HVAC Findings

Prepared by David Annan

Sep 17, 2024

#302 Condensate drains only have 1 union

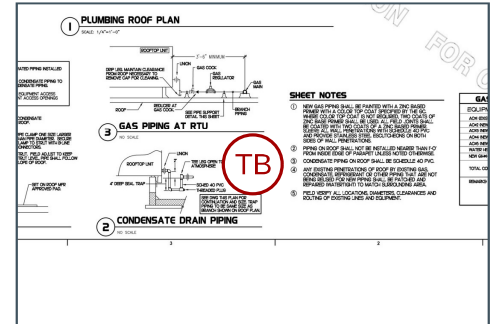
All condensate drains for the RTUs only have 1 union. The plans show 2 unions between the P-traps. Refer to page P3.1 "detail 2" for specifications.
